Product Change Notification Number: PDF-SF004

<b>Title: Adesto<sup>®</sup> Serial Flash &amp; DataFlash<sup>®</sup> Products Package Marking Change</b>		
<b>Product Identification:</b> All Adesto <sup>®</sup> Serial Flash and DataFlash Packages		
<b>Reason for Change:</b>	<input type="checkbox"/> Material / Composition <input type="checkbox"/> Processing / Manufacturing	<input type="checkbox"/> Design / Firmware <input checked="" type="checkbox"/> Logistics <input type="checkbox"/> Manufacturing Location <input type="checkbox"/> Quality / Reliability
<b>Change Description:</b>		
<b>Serial Flash &amp; DataFlash Product Line Package Marking Change.</b>		
<p>As previously communicated, (ATMEL PCN SC124101), Adesto Technologies Corporation acquired Atmel's Serial Flash and DataFlash product lines on Oct 1<sup>st</sup>, 2012. As part of the transition, Adesto is replacing the Atmel name on newly assembled parts with "adesto". The parts include:</p>

*Table 2: Adesto Top Marked Package Summary*

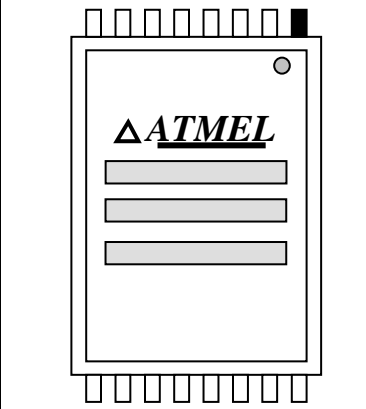
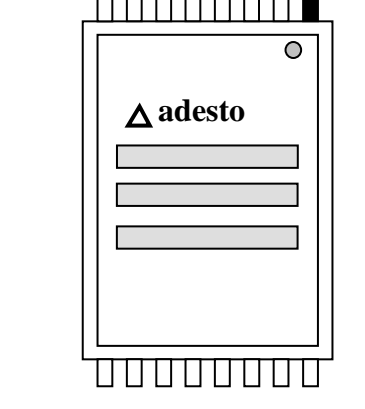
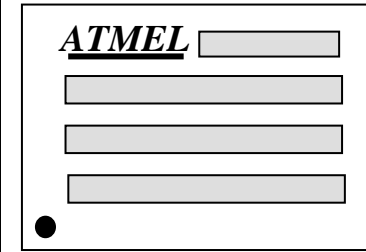
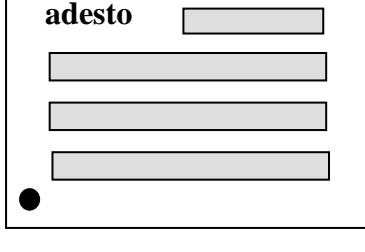
Package	Old Marking	New Marking	Package Code
8pin SOIC			S, SS
8pin DFN (MLF)			M, MW, MA
8pin CASON			CN
28pin TSOP			T
24 Ball BGA			C
